Appendix E – Facility Reports - Buildings

City Hall - Exterior
 401 Grove Street
 Healdsburg, CA

Villa Chanticleer Annex - Exterior & First Floor
 1248 North Fitch Mountain Road
 Healdsburg, CA

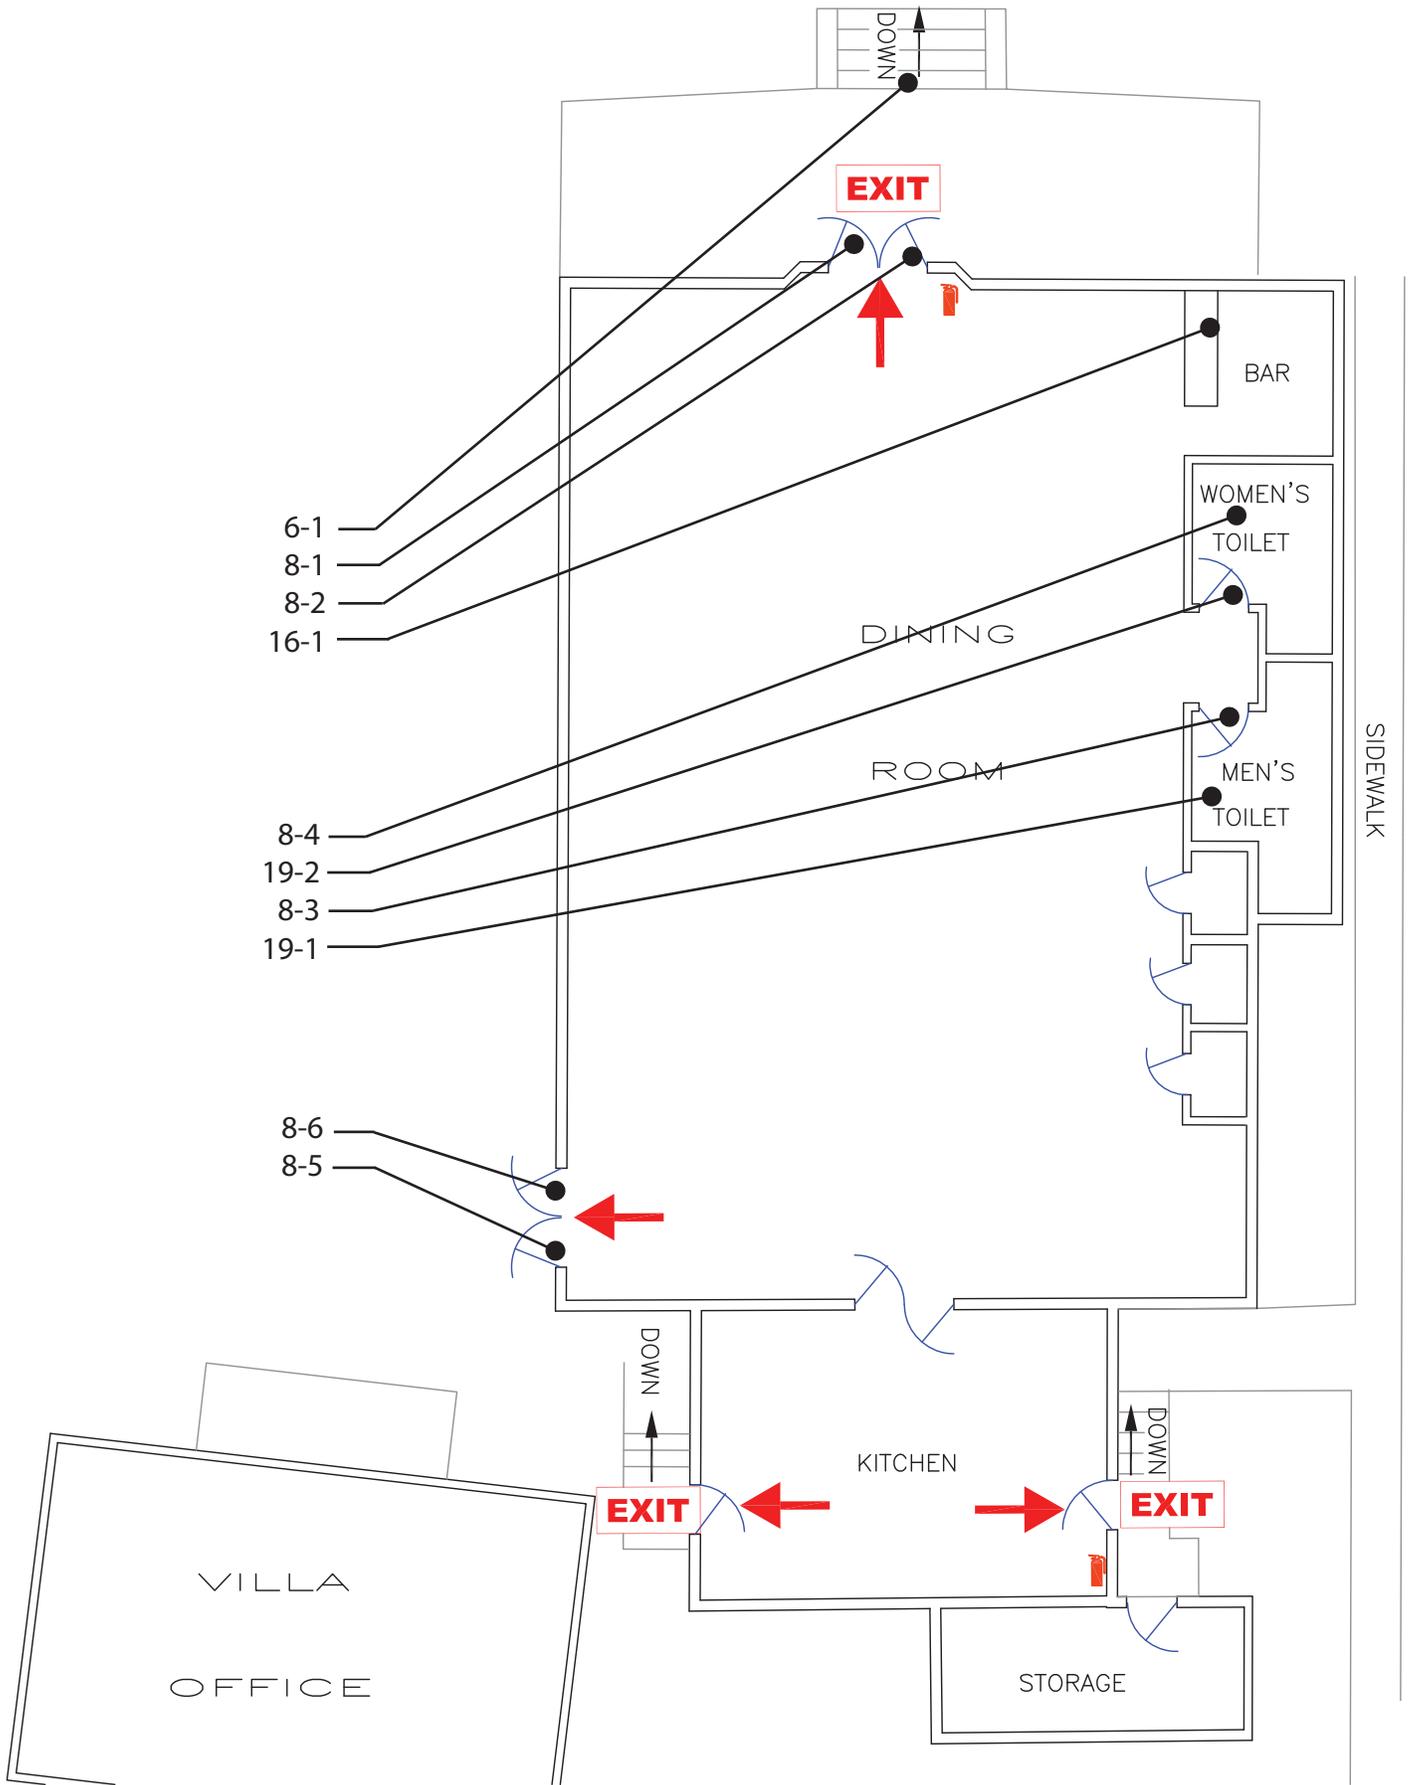
Floor 1		
8 - 1	Door/Gate	Priority:2
Provide an accessible path of travel		\$0
Notes: Accessible route to the door is not provided due to stair access. However doors 8-5 and 8-6 provide an accessible entrance, thus providing equivalent facilitation.		
State: 1133B.1.1.1.1		
Federal: 4.3.2		
Provide sign(s) indicating accessible entries and facilities		\$250
Notes: Directional signage is not provided to indicate the location of accessible entries.		
State: 1117B.5, 1117B.5.1.2, 1117B.5.8.1.2, 1127B.3		
Federal: 4.3.16		
Replace or modify door threshold		\$300
Notes: Threshold is 1" (1/2" max) high. Grind down.		
State: 1133B.2.4.1		
Federal: 4.13.8		
Enlarge door opening		\$3,500
Notes: Width of clear opening is 27.75" (32"min). Height of clear opening is 78" (80" min).		
State: 1008.11, 1133B.2.2, 1133B.2.3		
Federal: 4.13.5, 4.4.2		
Provide or modify door kickplate		\$100
Notes: Doorstop is mounted on kickplate.

Floor 1		
8 - 2	Door/Gate	Priority:2
Provide an accessible path of travel		\$0
Notes: Accessible route to the door is not provided due to stair access. However doors 8-5 and 8-6 provide an accessible entrance, thus providing equivalent facilitation.		
State: 1133B.1.1.1.1		
Federal: 4.3.2		
Replace or modify door threshold		\$300
Notes: Threshold is 1" (1/2" max) high. Grind down.		
State: 1133B.2.4.1		
Federal: 4.13.8		
Enlarge door opening		\$3,500
Notes: Width of clear opening is 27.75" (32"min). Height of clear opening is 78" (80" min).		
State: 1008.11, 1133B.2.2, 1133B.2.3		
Federal: 4.13.5, 4.4.2		
8 - 3	Door/Gate	Priority:2
Enlarge door opening		\$3,500
Notes: Width of clear opening is 31" (32"min).		
State: 1133B.2.2, 1133B.2.3		
Federal: 4.13.5		
Provide additional strike edge clearance		\$3,000
Notes: Strike-edge clearance on the swing-side of the door is 3.5" (18" min).		
State: 1133B.2.4.3		
Federal: 4.13.6

8 - 4	Door/Gate	Priority:2
Enlarge door opening		\$3,500
Notes: Width of clear opening is 31.5" (32"min).		
State: 1133B.2.2, 1133B.2.3		
Federal: 4.13.5		
Provide additional strike edge clearance		\$3,000
Notes: Strike-edge clearance on the swing-side of the door is 4" (18" min).		
State: 1133B.2.4.3		
Federal: 4.13.6

Floor 1		
8 - 5	Door/Gate	Priority:2
Provide sign(s) indicating accessible entries and facilities		\$250
Notes: Accessible entry is not marked with the International Symbol of Accessibility.		
State: 1117B.5.8.1.2, 1127B.3		
Federal: 4.13.6		
Provide or modify door kickplate		\$100
Notes: Doorstop is mounted on kickplate.		
State: 1133B.2.6		
Federal: -		
Install or modify permanent room signs		\$250
Notes: There is an illuminated exit sign but tactile sign is not provided.		
State: 1011.3 #3		
Federal: -		
8 - 6	Door/Gate	Priority:2
Provide or modify door kickplate		\$100
Notes: Doorstop is mounted on kickplate.		
State: 1133B.2.6		
Federal: -		
16 - 1	Transaction Counter	Priority:2
Provide an accessible counter		\$4,000
Notes: Transaction counter is 43.5" (34" max) AFF.		
State: 1122B.5		
Federal: 4.32.4

Floor 1		
19 - 1	Multiple User Restroom	Priority:2
Install sign		\$250
Notes: California required sign is not provided on the door.		
State: 1115B.6		
Federal: 4.30.4		
Install sign		\$250
Notes: Federal required sign is not provided on the latch side of the door.		
State: 1115B.6, 1117B.5.1 #1		
Federal: 4.30.4		
Increase or provide maneuvering or clear floor area		\$2,500
Notes: Turning area is 24" (60" min. in diameter).		
State: 1115B.3.1 #1		
Federal: 4.23.3		
Replace or reposition dispensers or mirrors		\$200
Notes: Mirror is mounted so bottom of reflecting surface is 54" (40" max) AFF.		
State: 1115B.8.1		
Federal: 4.19.6		
Replace or reposition dispensers or mirrors		\$400
Notes: Towel dispenser is mounted 43" (40" max) and soap dispenser is mounted 43" (40" max) AFF.		
State: 1115B.8.3		
Federal: 4.23.7		
Modify lavatory/counter clearances		\$3,500
Notes: Lavatory sink has 5" (19" min) clear floor space underneath the lavatory. Clear space beneath the lavatory sink is 28" (29" min) high. The space under the bowl is 25.5" (27" min) when measured 8" from the front edge.

Floor 1		
19 - 1	Multiple User Restroom	Priority:2
Replace or reposition urinal		\$3,500
Notes: Urinal is 24.5" (17" max) from the floor to the lip. Urinal rim projects 13.75" (14" min) from the wall.		
State: 1115B.4.2 #1		
Federal: 4.18.2		
Provide or replace stall door hardware		\$100
Notes: U-shape handle is not provided on the back of the compartment door.		
State: 1115B.3.1 #4.5		
Federal: 4.13.9		
Modify stall partitions and doors		\$500
Notes: Space from the wall to the edge of the water closet is 31" (32" min).		
State: 1115B.4.1 #1		
Federal: 4.17.3		
Modify stall partitions and doors		\$500
Notes: Compartment width is 57" (60" min).		
State: -		
Federal: 4.17.3		
Replace or reposition dispensers or mirrors		\$100
Notes: Second roll on the toilet paper dispenser is mounted 38" (36" max) from the back wall.		
State: 1115B.8.4		
Federal: 4.16.6		
Replace or reposition dispensers or mirrors		\$100
Notes: Seat cover dispenser is mounted 48.5" (40" max) AFF.

Floor 1		
19 - 2	Multiple User Restroom	Priority:2
Install sign		\$250
Notes: California required sign is not provided on the door.		
State: 1115B.6		
Federal: 4.30.4		
Install sign		\$250
Notes: Federal required sign is not provided on the latch side of the door.		
State: 1115B.6, 1117B.5.1 #1		
Federal: 4.30.4		
Increase or provide maneuvering or clear floor area		\$2,500
Notes: Turning area is 32" (60" min. in diameter).		
State: 1115B.3.1 #1		
Federal: 4.23.3		
Replace or reposition dispensers or mirrors		\$200
Notes: Mirror is mounted so bottom of reflecting surface is 46.5" (40" max) AFF.		
State: 1115B.8.1		
Federal: 4.19.6		
Modify lavatory/counter clearances		\$3,500
Notes: Clear space beneath the lavatory sink is 27" (29" min) high. The space under the bowl is 24" (27" min) when measured 8" from the front edge.		
State: 1115B.4.3 #2		
Federal: 4.19.2		
Insulate water lines		\$100
Notes: Pipes are not insulated.

Senior Center - Exterior & First Floor
 133 Matheson Street
 Healdsburg, CA

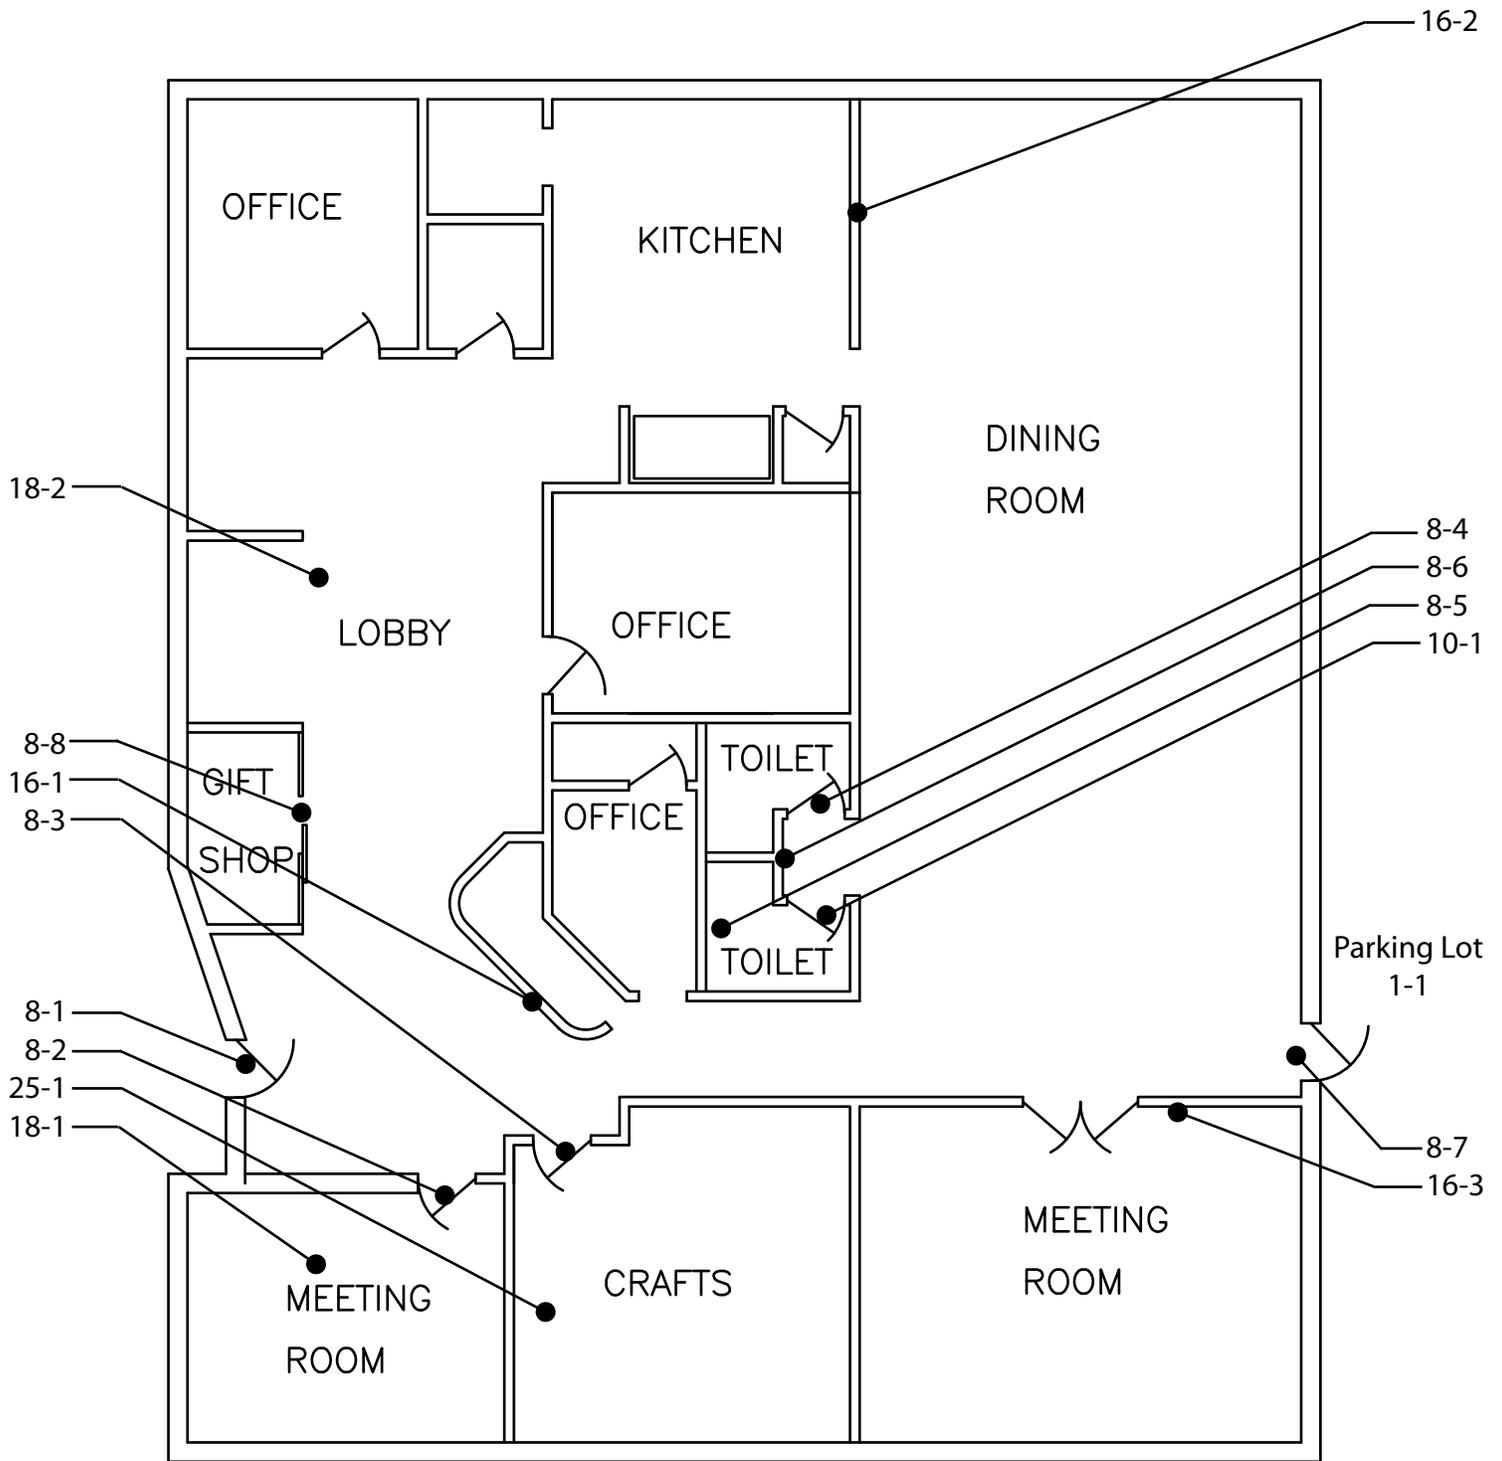
Exterior		
1 - 1	Parking Area	Priority: 1
Install sign		\$100
Notes: Additional sign stating "Minimum Fine \$250" not provided.		
State: 1129B.4		
Federal: -		
Provide or modify accessible access aisles		\$150
Notes: Access aisle is not provided.		
State: 1129B.3 #1, 1129B.3 #2, 1129B.4 #1		
Federal: 4.6.3		
Install sign for unauthorized parking		\$400
Notes: Warning sign is not provided.		
State: 1129B.4, 1133B.8.6.3		
Federal: -		
Regrade surface		\$1,800
Notes: Slope in the accessible parking space is 6.3% (2% max). Regrade slope to not exceed 2% in any direction.		
State: 1129B.3 #4		
Federal: 4.6.3		
Install van parking sign		\$250
Notes: Van parking sign is not provided.		
State: 1129B.4		
Federal: 4.6.4		
Provide or modify accessible spaces		\$250
Notes: Stall length is 16' (18' min).		
State: 1129B.4 #1		
Federal: 4.6.3

Floor 1		
8 - 1	Door/Gate	Priority: 1
Install or modify permanent room signs		\$250
Notes: There is an illuminated exit sign but tactile sign is not provided.		
State: 1011.3 #3		
Federal: -		
8 - 2	Door/Gate	Priority: 2
Provide or modify door kickplate		\$100
Notes: Kickplate is 8.75" (10" min) high.		
State: 1133B.2.6		
Federal: -		
8 - 3	Door/Gate	Priority: 2
Provide or modify door kickplate		\$100
Notes: Kickplate is 8.75" (10" min) high.		
State: 1133B.2.6		
Federal: -		
8 - 4	Door/Gate	Priority: 2
Provide additional strike edge clearance		\$3,000
Notes: Strike-edge clearance on the swing-side of the door is 5" (18" min).		
State: 1133B.2.4.3		
Federal: 4.13.6		
Provide additional strike edge clearance		\$3,000
Notes: Strike-edge clearance on the push-side of the door is 5" (12" min).		
State: 1133B.2.4.3		
Federal: 4.13.6		
8 - 5	Door/Gate	Priority: 2
Provide additional strike edge clearance		\$3,000
Notes: Strike-edge clearance on the push-side of the door is 5" (12" min).

Floor 1		
8 - 6	Door/Gate	Priority:2
Provide additional strike edge clearance		\$3,000
Notes: Strike-edge clearance on the swing-side of the door is 3" (18" min) due to stall obstruction.		
State: 1133B.2.4.3		
Federal: 4.13.6		
Increase or provide maneuvering or clear floor area		\$2,500
Notes: Clear level space on the push-side of the door is 42" (48" min).		
State: 1133B.2, 1133B.2.4.2, 1133B.7.5		
Federal: 4.13.6		
8 - 7	Door/Gate	Priority:2
Provide additional strike edge clearance		\$3,000
Notes: Strike-edge clearance on the swing-side of the door is 5.75" (18" min).		
State: 1133B.2.4.3		
Federal: 4.13.6		
Provide additional strike edge clearance		\$3,000
Notes: Strike-edge clearance on the push-side of the door is 8.75" (12" min).		
State: 1133B.2.4.3		
Federal: 4.13.6		
Install or modify permanent room signs		\$250
Notes: There is an illuminated exit sign but tactile sign is not provided.		
State: 1011.3 #3

Floor 1		
10 - 1	Drinking Fountain	Priority:3
Replace or reposition drinking fountain		\$3,500
Notes: "Hi-lo" drinking fountain is not provided. Knee height is 20.25" (27" min). Depth is 9.25" (18" to 19"). Bubbler height is 42.5" (36" max) AFF.		
State: 1115B.4.6 #1, 1115B.4.6 #2, 1115B.4.6 #4, 1117B.4.6 #2		
Federal: 4.1.6, 4.15.2, 4.15.5		
16 - 1	Transaction Counter	Priority:2
Provide an accessible counter		\$4,000
Notes: Transaction counter is 41-7/8" (28" to 34") high.		
State: 1122B.5		
Federal: 4.32.4		
16 - 2	Transaction Counter	Priority:2
Provide an accessible counter		\$4,000
Notes: Counter is 36" (28" to 34") high.		
State: 1122B.5		
Federal: 4.32.4		
18 - 1	Room	Priority:2
Remove overhanging or protruding objects		\$100
Notes: Mounted television protrudes 14.25" (4" max) at 47.5" (not between 27" to 80") AFF. Relocate television or place something underneath that is cane detectable.		
State: 1133B.8.6.1

Floor 1	
25 - 1	Kitchen
Priority: 2	
Provide an accessible counter	\$4,000
Notes: Counter is 36.25" (28" to 34") AFF. Base cabinets directly under the sink does not provide clearance for a wheelchair.	
State: 1115B.4.7 #1	
Federal: 1115B.4.7 #1	
Modify lavatory/counter clearances	\$3,500
Notes: Sink depth is 10" (6.5" max).	
State: 1115B.4.7 #1	
Federal: 4.24.4	
Replace or reposition dispensers or mirrors	\$400
Notes: Towel dispenser is mounted 51" (40" max) and soap dispenser is mounted 47.5" (40" max). Lower dispensers.	
State: 1115B.9.2	
Federal: 4.23.7

Public Library - First Floor
 139 Piper Street
 Healdsburg, CA

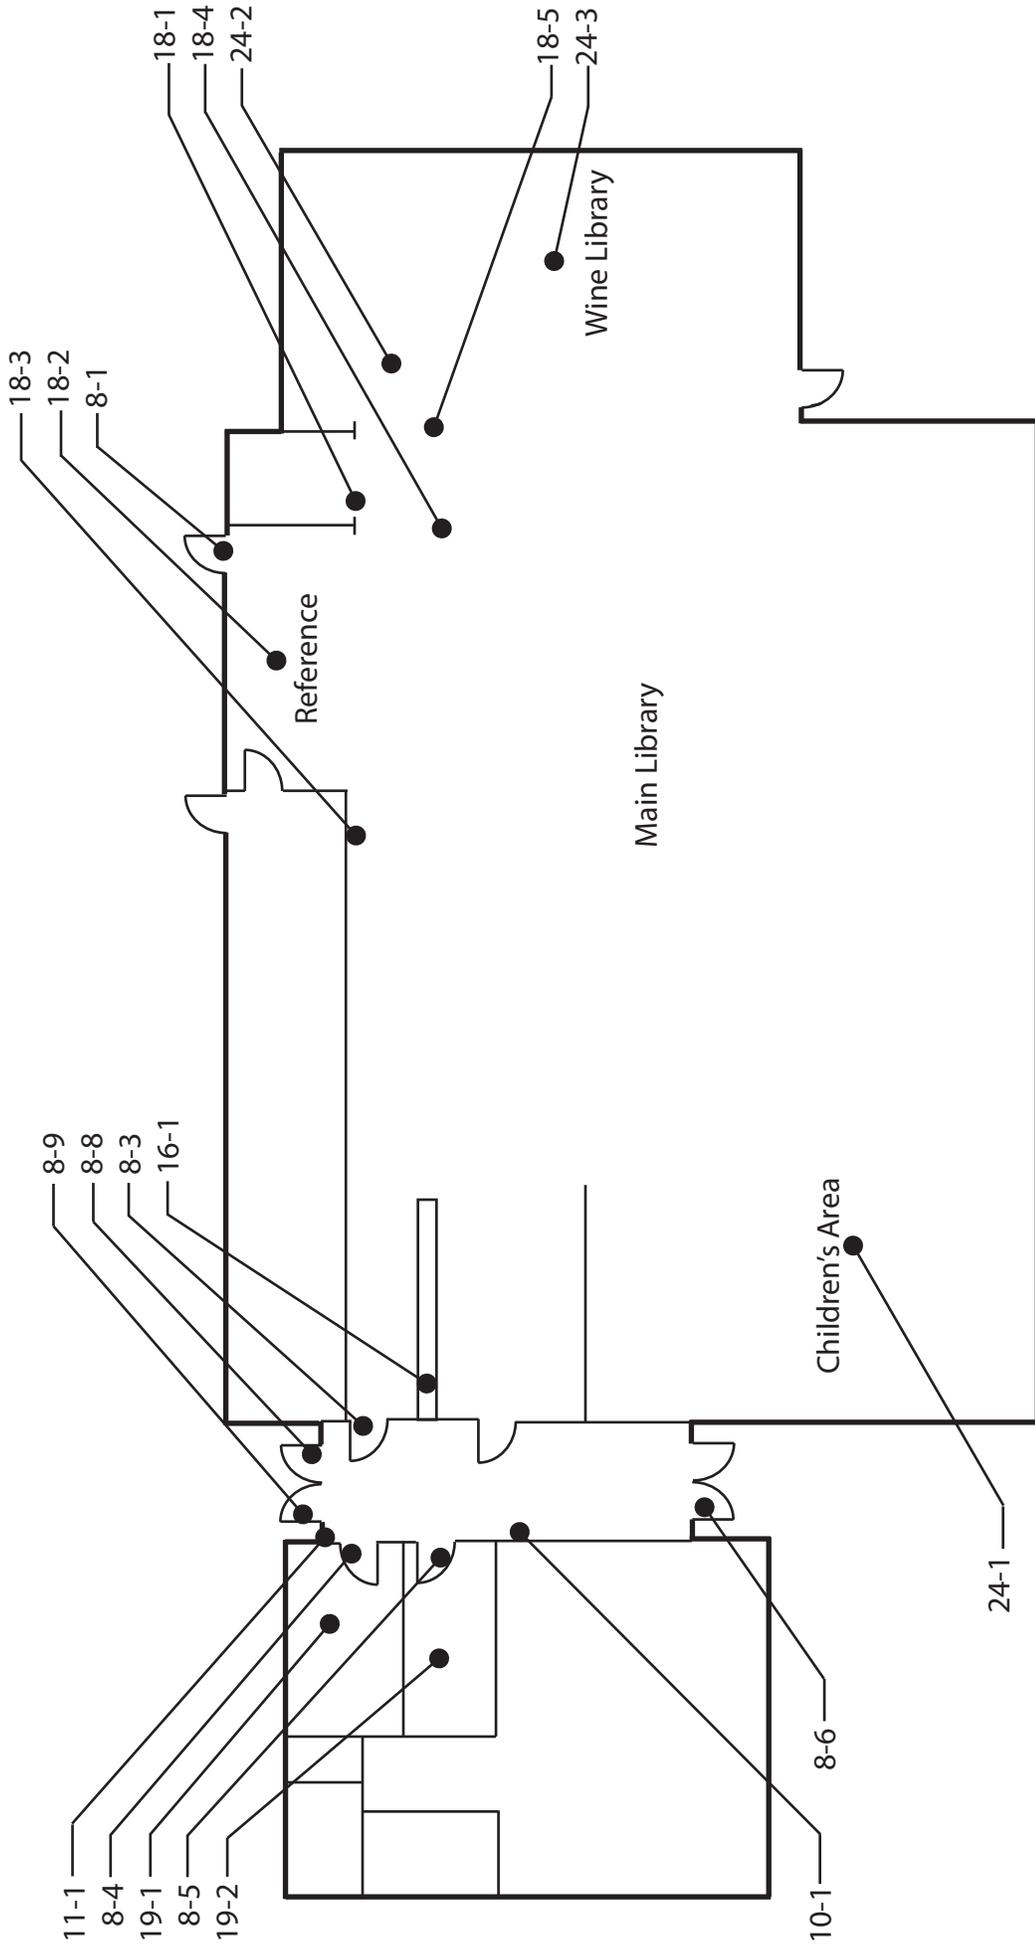
State: 1115B.4.2 #1		
Federal: 4.18.2, 4.18.3		
Provide or replace stall door hardware		\$200
Notes: U-shape handle not provided on the front or back of compartment door. Compartment door is not self-closing.		
State: 1115B.3.1 #4.5		
Federal: 4.13.9		
Replace or reposition dispensers or mirrors		\$100
Notes: Coat hook is mounted 66" (48" max) AFF.		
State: 1118B.5		
Federal: A4.27

State: 1118B.5		
Federal: A4.27		
Reposition toilet flush controls		\$750
Notes: Flush control is not located on the wide side.		
State: 1115B.4.1 #5		
Federal: 4.16.5		
Replace toilet or adjust toilet seat height		\$3,500
Notes: Toilet seat height is 20.25" (17" to 19") AFF.		
State: 1115B.4.1 #4		
Federal: 4.16.3

Floor 1		
19 - 2	Multiple User Restroom	Priority:2
Replace or reposition fixtures		\$1,000
Notes: Space from the wall to the centerline of the water closet is 18.5" (18" absolute).		
State: 1115B.7.1.3		
Federal: 4.17.3		
Replace or reposition dispensers or mirrors		\$100
Notes: Seat cover dispenser is mounted 48" (40" max) AFF.		
State: 1115B.8.3		
Federal: 4.23.7		
Replace or modify grab bars		\$350
Notes: Side grab bar is positioned so the front end is 52" (54" min) from the back wall.		
State: 1115B.4.1 #3.1		
Federal: 4.17.6		
Replace or reposition dispensers or mirrors		\$200
Notes: Soap dispenser is mounted 45" (40" max) AFF.		
State: 1115B.8.3		
Federal: 4.23.7		
24 - 1	Library	Priority:2
Widen aisles		\$750
Notes: Children's area: Main aisles range from 31" to 34" (44" min).		
State: 1106B.4 #2		
Federal: 8.5		
24 - 2	Library	Priority:2
Adjust shelving, storage, or work space		\$2,500
Notes: Microform Catalog Cabinets: Height of the highest handle is 56" (54" max) for front approach. However, librarian assistance provides equivalent facilitation.

State: 1106B.4 #4		
Federal: 4.2.6		
24 - 3	Library	Priority:2
Widen aisles		\$750
Notes: Wine Catalog Section: Main aisles range from 40" to 44" (44" min).		
State: 1106B.4 #2		
Federal: 8.5		
Adjust shelving, storage, or work space		\$2,500
Notes: Wine Files.org Cabinets: Height of the highest handle is 47" (54" max) for front approach. However, librarian assistance provides equivalent facilitation.		
State: 1106B.4 #4		
Federal: 4.2.6
